RWCF Modifications Project

East Bank Outfall

Construction Change Order (CCO)-008

Water Advisory Group

Work No Longer Needed (Temporary)

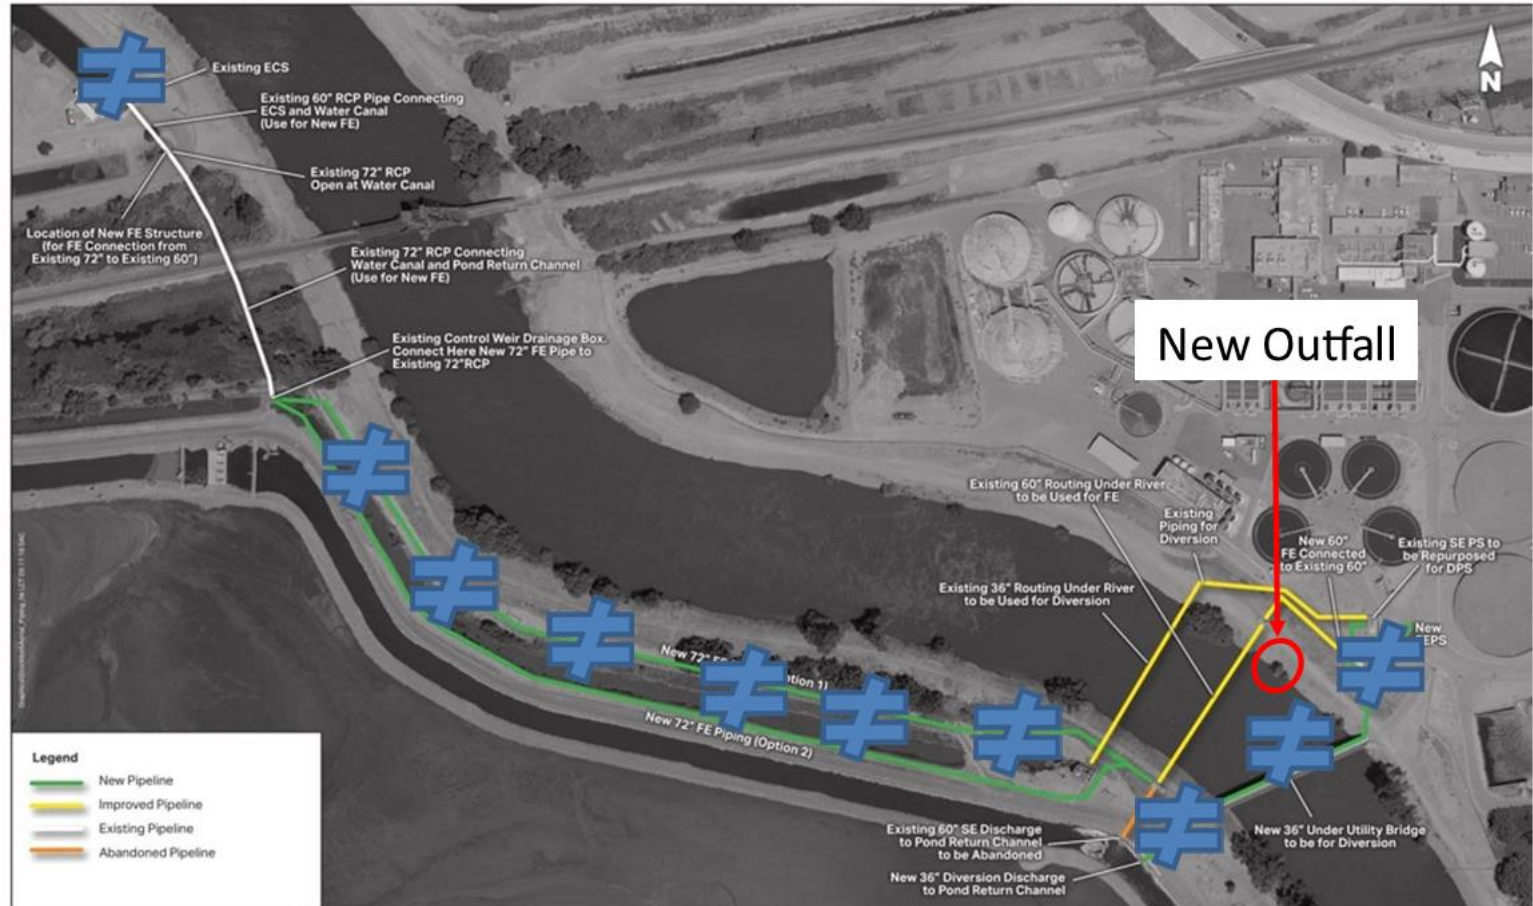
East Bank Outfall Construction
